**City of Hayward
Development Review Process
Focus Group Meeting**

**Wednesday, April 3, 2013
Hayward City Hall, Room 2A
10:00 am – Noon**

Address: 25601 Clawiter Road (J.J. Truck Repair)

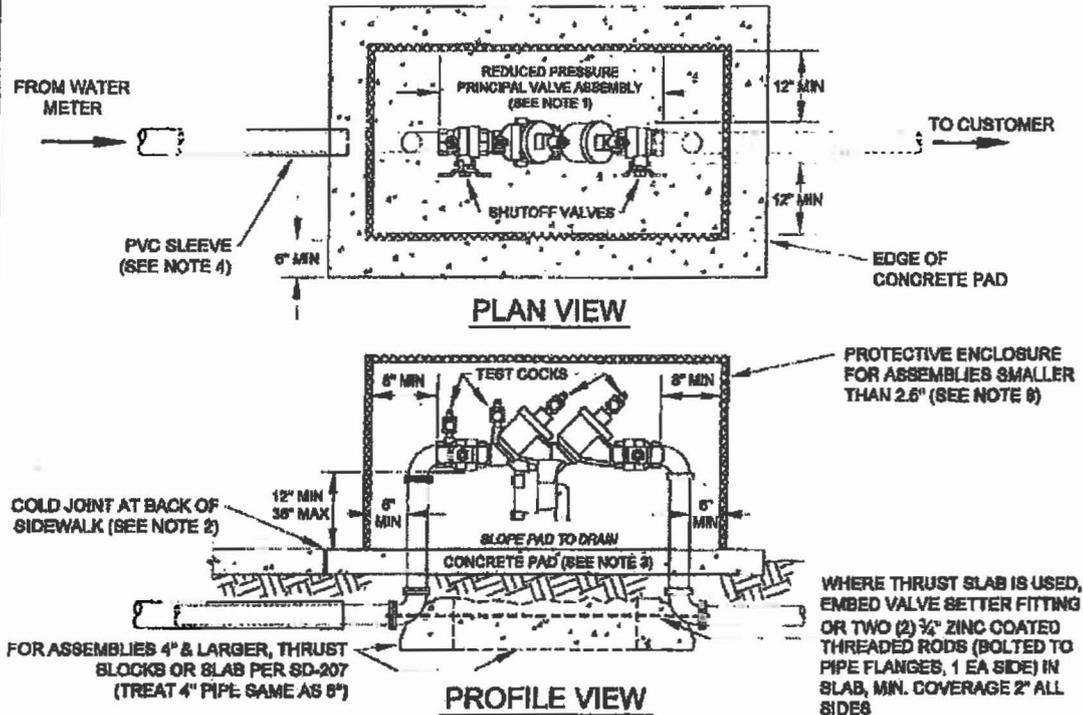
1. The applicant/developer shall install a Reduced Pressure Backflow Prevention Assembly on each domestic and irrigation water meter, per City Standard SD-202. Backflow Prevention Assemblies shall be at least the size of the water meter or the water line on the property side of the meter, whichever is bigger. City records indicate that the existing

domestic water meter and the existing irrigation meter are both unprotected. RP backflow devices must be installed on the existing domestic meter, the existing irrigation meter and the new domestic meter. Please contact the Cross Connection Control Specialist, Kathy Richards, at (510) 881-7965, once the backflow device has been installed so that it can be inspected and tested.

Condition of Approval: Prior to Final Inspection/Approval, City Inspector shall confirm that the both domestic water services and the irrigation water service are equipped with a Reduced Pressure Backflow Prevention Assembly, per City of Hayward Standard Detail SD-202.

Enclosure Specifications

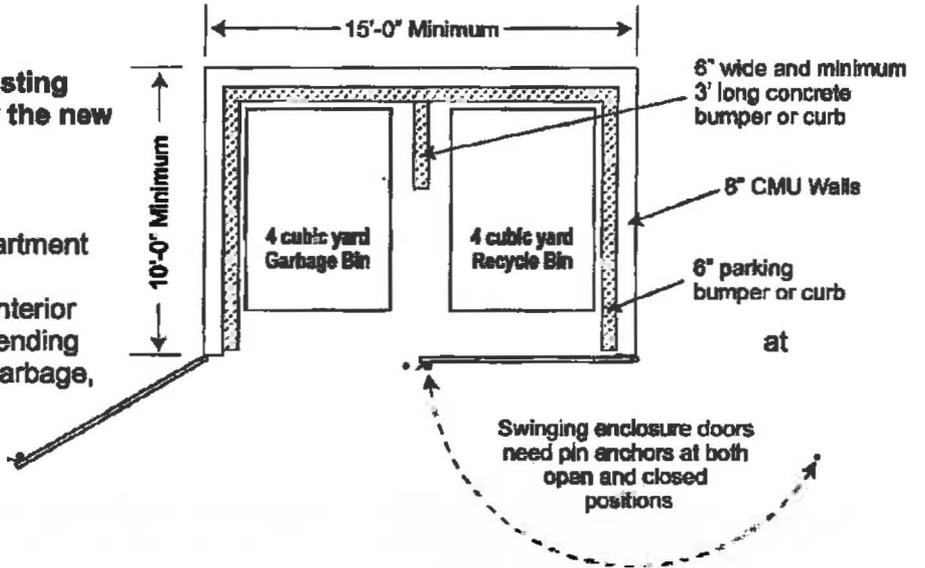
- Please provide photos of the existing canopy that is intended to cover the new trash enclosure.
- 8" CMU walls or fencing, or other requirements set by Planning Department
- 6" wide curb or bumper along the interior perimeter of the enclosure and extending least three feet long between the garbage, recycling, and/or organics bins
- A minimum space of 12 inches between containers and the walls of the enclosure to allow for maneuvering the containers

- Gates that hinge from the corners of the enclosure to allow for maximum accessibility to the containers
- Enclosures must be constructed on a flat area with no more than a 2% grade
- If the existing or new business will generate organics for disposal, a roof over the enclosure is required. (National Pollution Discharge Elimination System, Federal Clean Water Act). For questions, contact Jim Lear at 583-4785.

- A concrete pad extending 20' from the enclosure to accommodate for truck weight is recommended.
- Signage indicating "Garbage Only" on one side of the enclosure and "Recyclables Only" on the other. If an organics bin is planned for, signage indicated "Organics" is required.

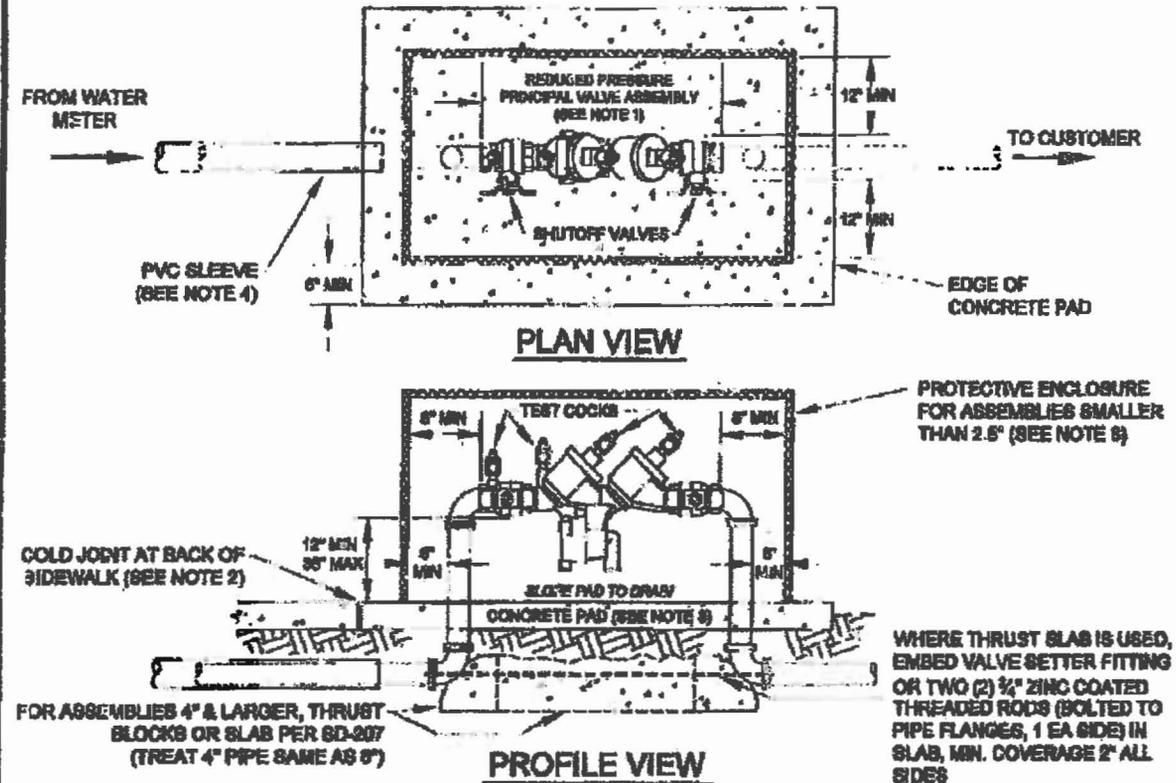
2. All domestic and irrigation services must be equipped Reduced Pressure (RP) Backflow Prevention Assemblies, per City of Hayward Standard Detail SD-202 (copy attached). City records indicate that the existing irrigation water service and the existing domestic service are both equipped with Double Check (DC) Valve Assemblies. The DC Valve Assemblies on the both the irrigation and the domestic services must be changed to RP Backflow Prevention Assemblies. Please contact the Cross Connection Control Specialist, Kathy Richards, at (510) 881-7965, once the backflow devices have been installed so that they can be inspected and tested.

Condition of Approval: Prior to Final Inspection/Approval, City Inspector shall confirm that both domestic and irrigation water services are equipped with Reduced Pressure Backflow Prevention Assemblies, per City of Hayward Standard Detail SD-202.

Enclosure Specifications

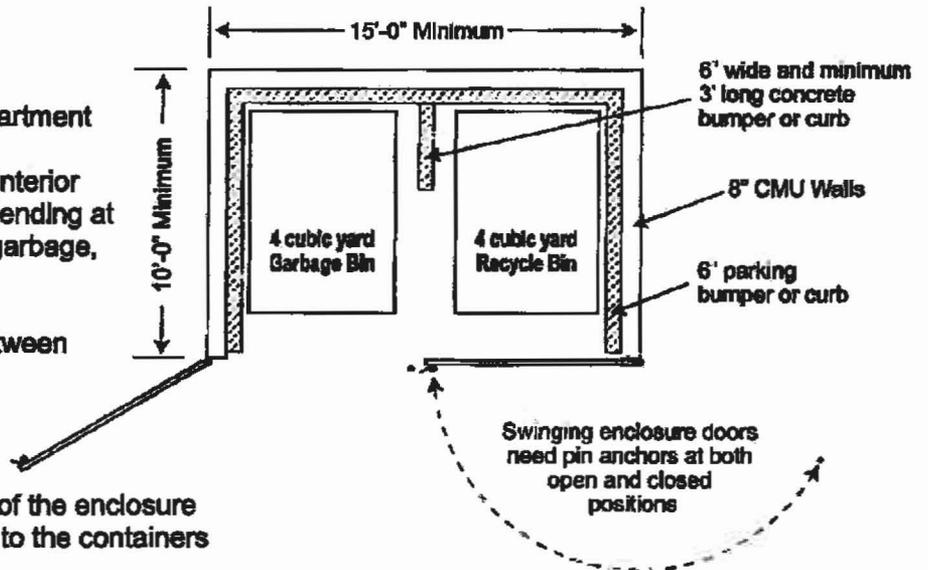
- 8" CMU walls or fencing, or other requirements set by Planning Department
- 6" wide curb or bumper along the interior perimeter of the enclosure and extending at least three feet long between the garbage, recycling, and/or organics bins
- A minimum space of 12 inches between containers and the walls of the enclosure to allow for maneuvering the containers
- Gates that hinge from the corners of the enclosure to allow for maximum accessibility to the containers
- Enclosures must be constructed on a flat area with no more than a 2% grade

6. If the existing or new business will generate organics for disposal, a roof over the enclosure is required. (National Pollution Discharge Elimination System, Federal Clean Water Act). For questions, contact Jim Lear at 583-4785.

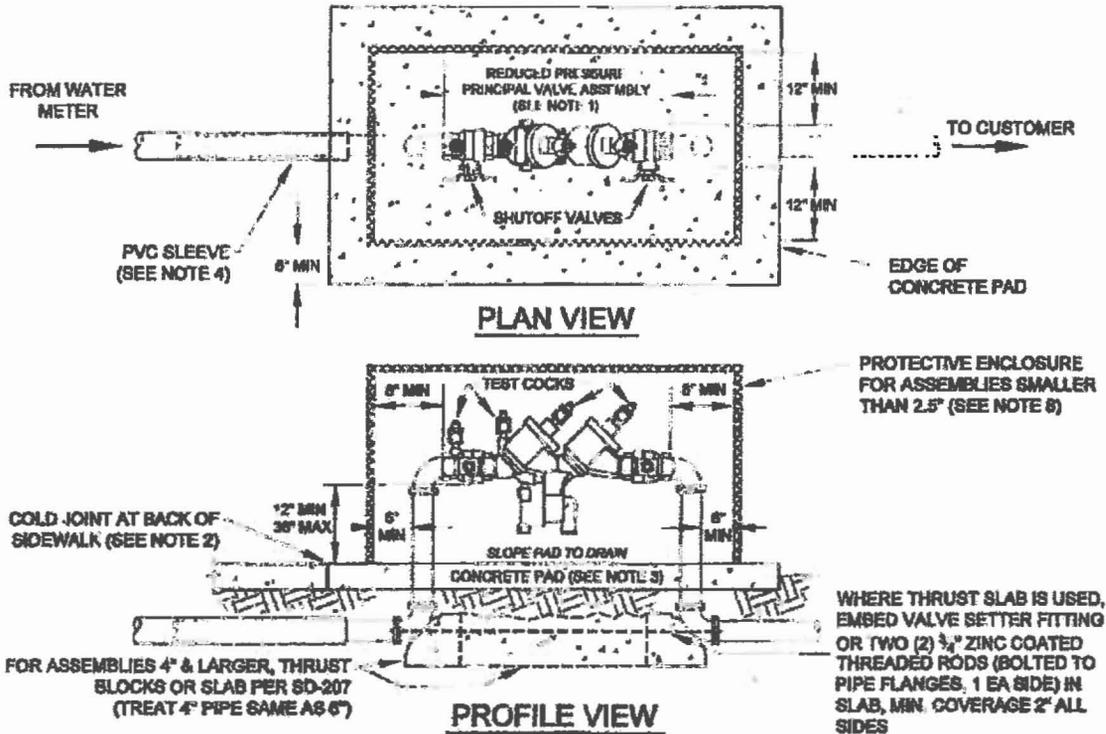
2. All domestic & irrigation water meters must have Reduced Pressure Backflow Prevention Assemblies, per City of Hayward Standard Detail 202. Backflow Prevention Assemblies shall be at least the size of the water meter or the water line on the property side of the meter, whichever is bigger. City records indicate that the existing domestic service is not protected. An RP Backflow Prevention Assembly must be installed on the domestic water service. Please contact the Cross Connection Control Specialist, Kathy Richards, at (510) 881-7965, once the backflow device has been installed so that it can be inspected and tested.

Condition of Approval: Prior to Final Inspection/Approval, City Inspector shall confirm that the domestic water service is equipped with Reduced Pressure Backflow Prevention Assemblies, per City of Hayward Standard Detail SD-202.
